TECHNICAL BULLETIN

Q447 UPS9814-1bNAS2
29 JAN 2015

SECTION: 418-02

Update Prior to Sale: Engine MIL Illuminated with DTC P25A2-00 Stored

E174971

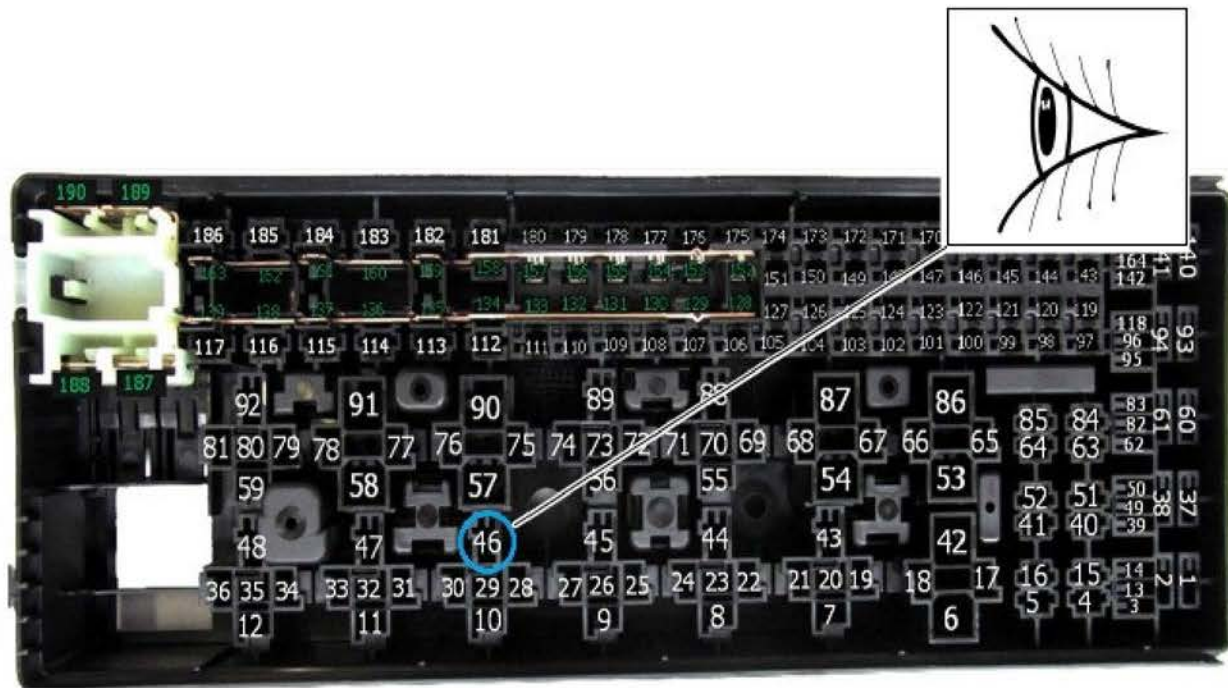
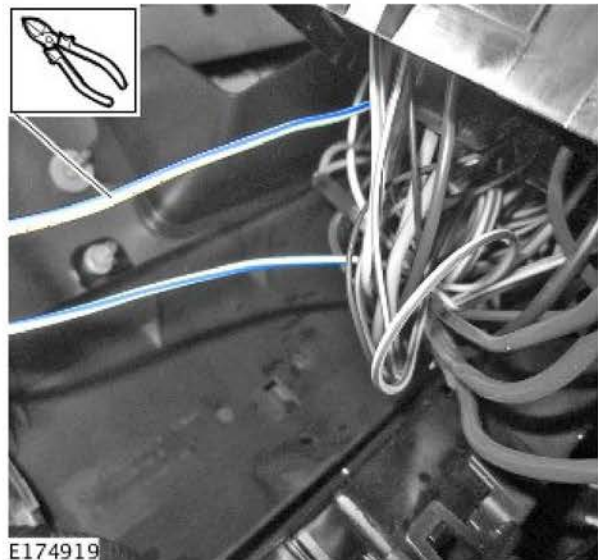
Locate the white/blue wire (pin number 46) from the rear of the junction box.

9. Using wire cutter, cut the wire (pin number 46) 250mm back from the connection at the junction box.

E174992

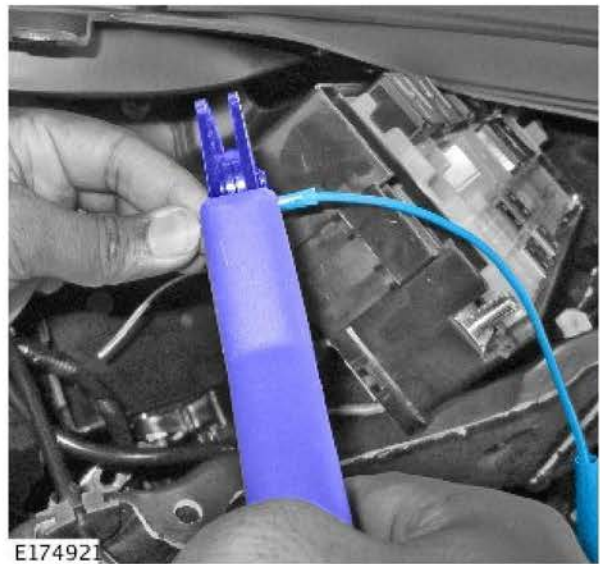
11.  **NOTE: The link lead provided (LR073319) is approximately 400 mm in length; cut into two 200mm-long pieces.**

Using wire cutter, cut the link lead (LR073319) in half; discard the female half as illustrated.

E174972

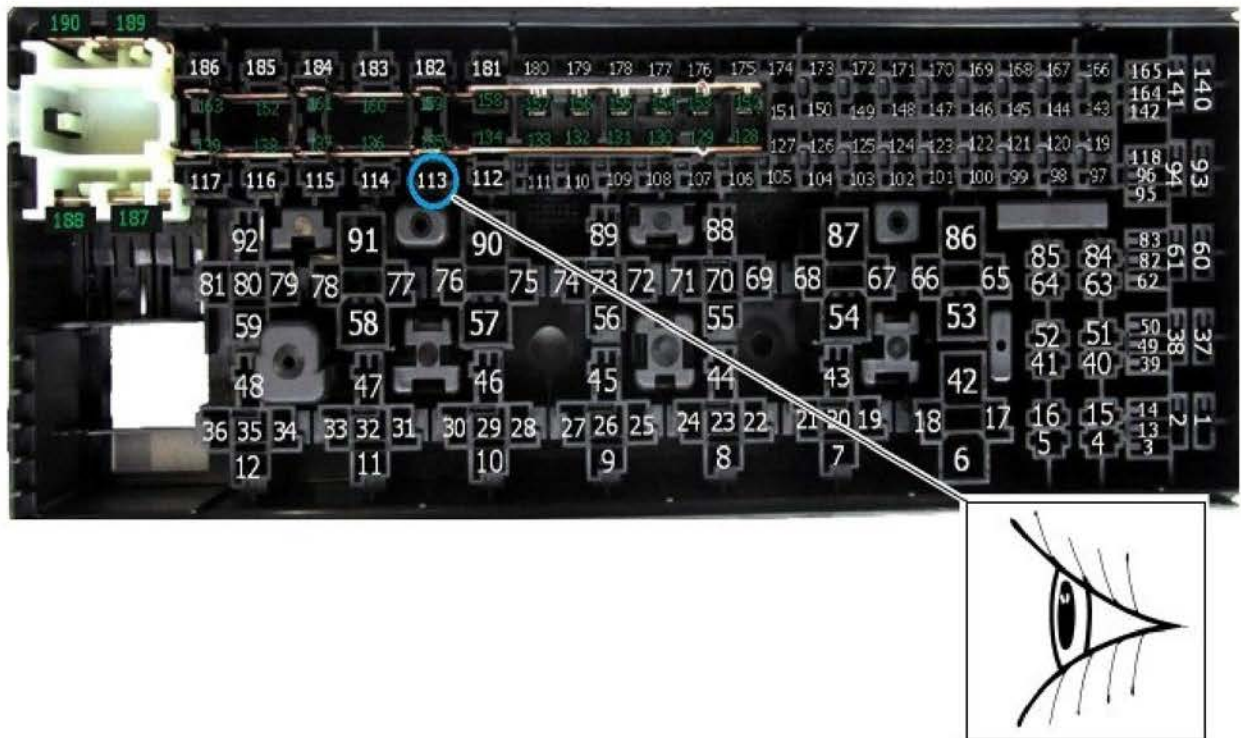
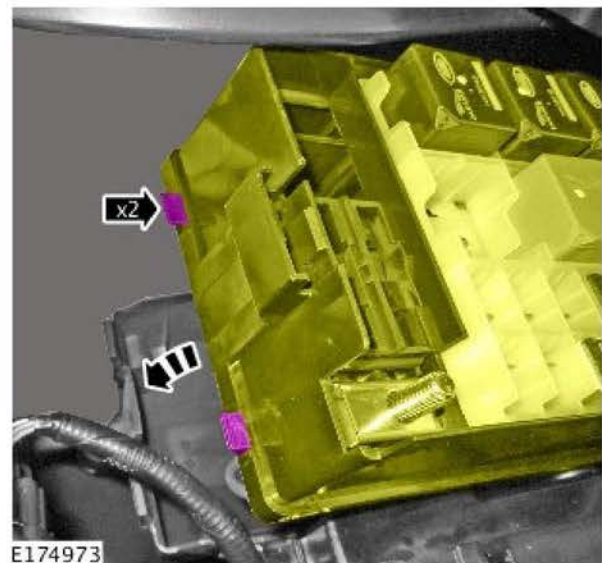
13. Install the male spade terminal of the link lead into cavity 113 in the rear of the junction box.

- An audible 'click' should be heard during insertion.
- Following insertion, move the wire forwards and backwards to make sure it is correctly engaged and has not released.
- Install the wiring harness link lead to the body wiring harness with electrical tape.
